415 West Hunt Club

<p>P2 Concepts 2200 THURSTON DR., UNIT 203 OTTAWA, ONTARIO, K1G 6E1</p>	<p>brian k. clark ARCHITECT</p> <p>141 Catherine Street, Suite 102 Ottawa, Ontario K2P 1C3 TEL: (613) 238-7412 FAX: 238-1799 Email: bkclarkarchitect@gmail.com</p>		CLIENT	STAMP	PROJECT	<p>DRAWING TITLE</p> <p>COSTCO HEAD OFFICE ADDITION</p>	<p>DRAWING NO.</p> <p>09</p> <p>07</p> <p>06</p> <p>05 ISSUED FOR SPC SUBMISSION 2024-09-19</p> <p>04 REVISED LANDSCAPING LAYOUT 2024-08-23</p> <p>03 ISSUED FOR COORDINATION 2024-08-08</p> <p>02 ISSUED FOR SITE PLAN APPROVAL 2024-04-19</p> <p>01 ISSUED FOR SITE PLAN APPROVAL 2023-12-15</p>	<p>DATE</p> <p>2024-08-23</p>	<p>PROJECT</p> <p>0350-018</p>	<p>SITE PLAN</p>	<p>SP-01</p>
			<p>DATE</p> <p>2024-08-23</p>	<p>PROJECT</p> <p>0350-018</p>	<p>REVISIONS</p> <p>DATE</p>

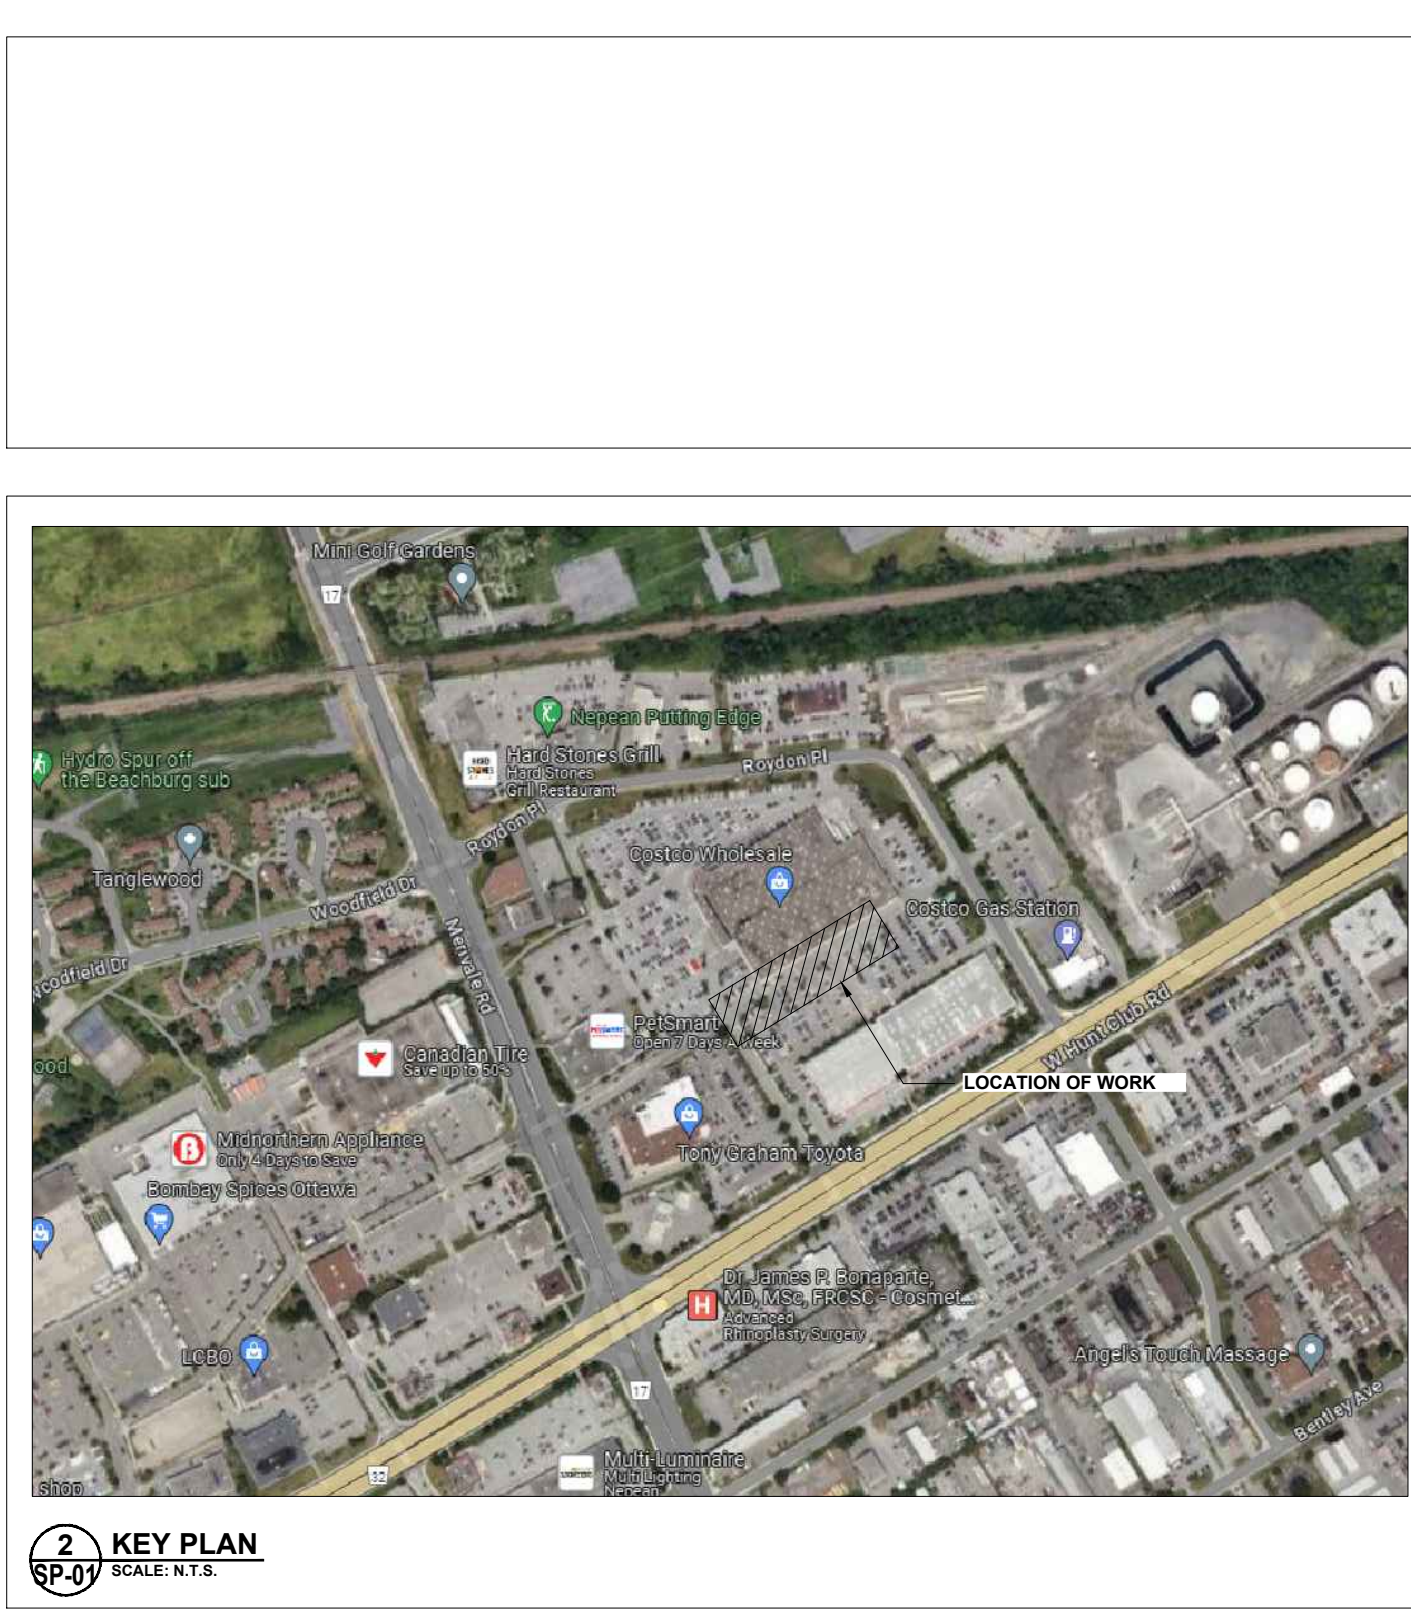
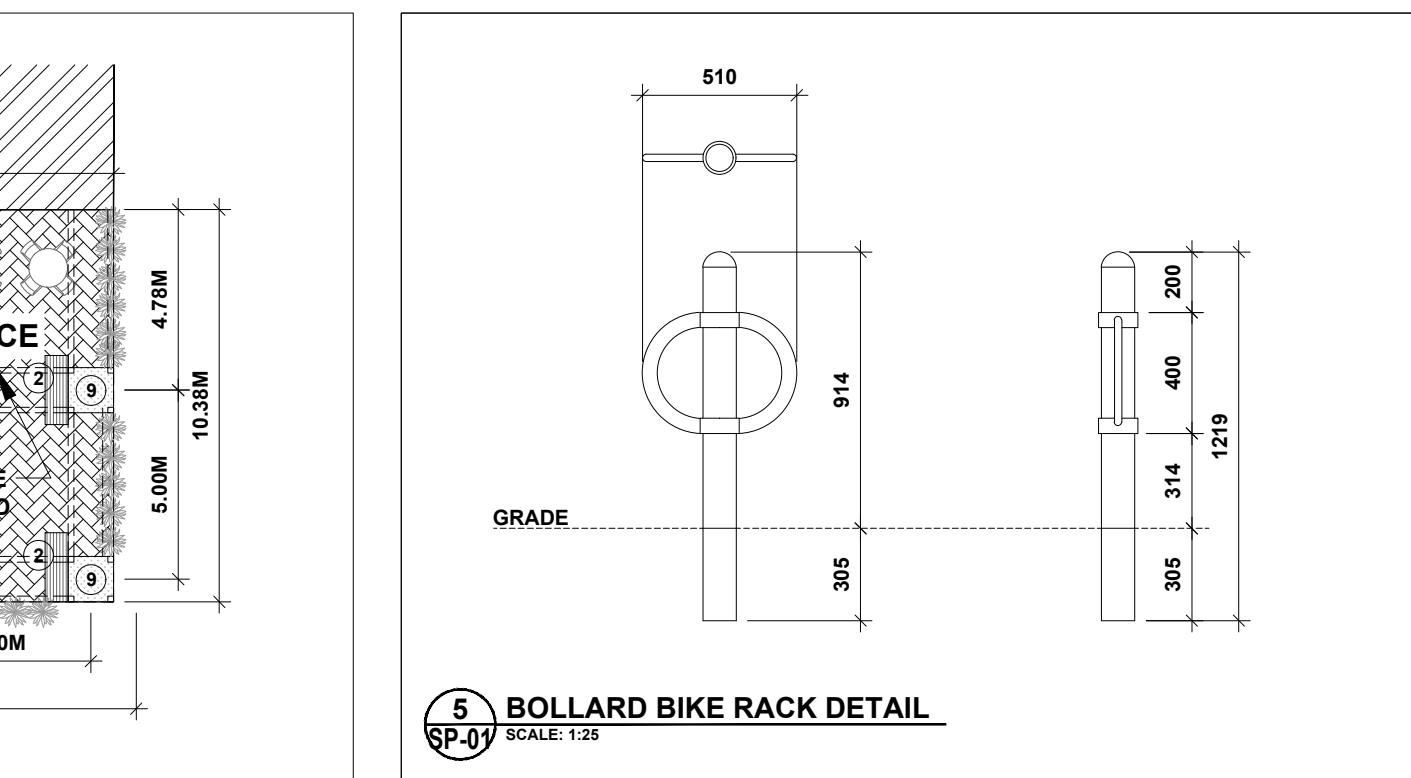
COMMENT: #7 - IDENTIFY LOCATION OF SNOW STORAGE

RESPONSE: #7 - SNOW TO BE REMOVED AND STORED OFF-SITE
